FACILITIES PROGRAM UPDATE
UTAH STATE DEVELOPMENTAL CENTER
ADMISSIONS AND SAFE HOUSING
895 NORTH 900 EAST, AMERICAN FORK, UTAH

DFCM PROJECT # 14068410

PROGRAM
SUPPLEMENT
#2

NOVEMBER 18, 2014

SITE UTILITIES

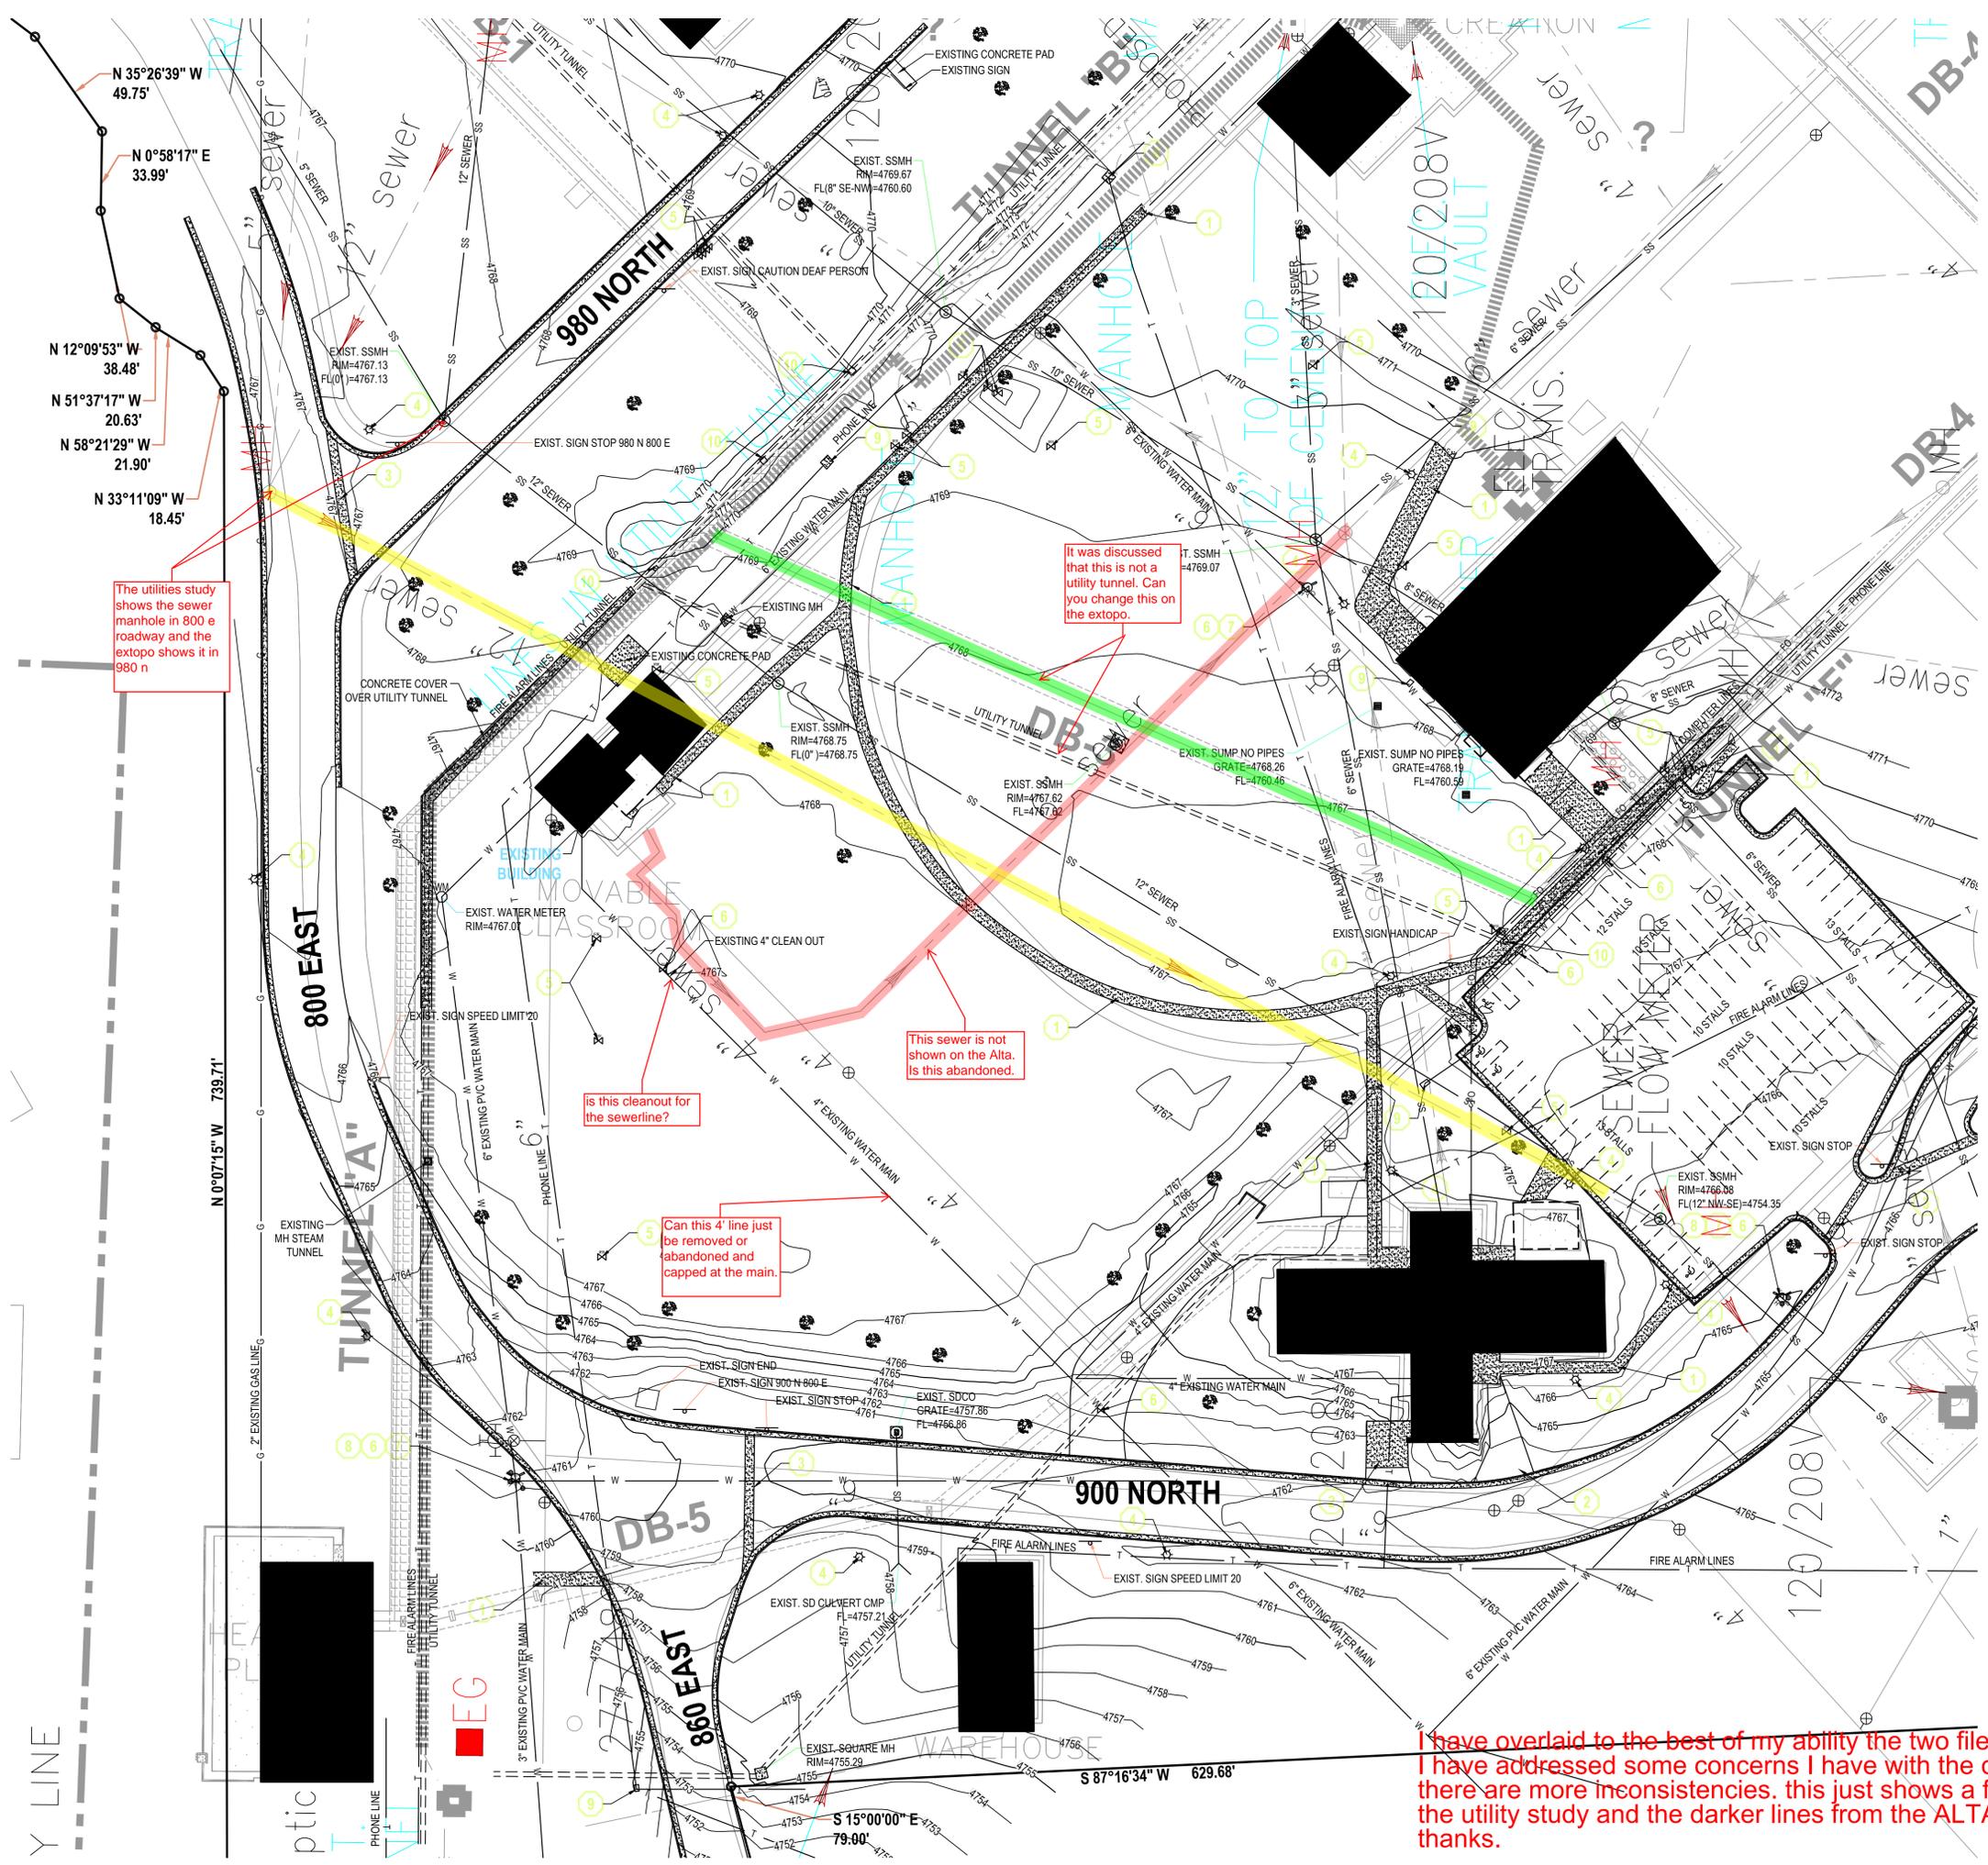
1. There are some conflicts between the utility locations shown on the separate existing files they you had previously sent to our team. We have attached a PDF outlines the discrepancies between the Alta survey and the utility study. Will you please help us understand whether the Alta survey or the utility study is correct at the redlined locations on the attached PDF?

The utilities study shows the sewer manhole in 800 e roadway and the extopo shows it in 980 n

It was discussed that this is not a utility tunnel. Can you change this on the extopo.

This sewer is not shown on the Alta. Is this abandoned.

is this cleanout for the sewerline?

Can this 4" line just be removed or abandoned and capped at the main.

CLARIFICATION: See Attachment #1

a. the 12" sewer man hole is located by the existing stop sign on 980 North.

b. The 4" existing water main will need to be relocated and possibly upgraded to be used for fire sprinkler and domestic use.

c. The sewer line that is shown as abandoned, is the old sewer line for the building that was torn down, it is probably disconnected right after the sidewalk.
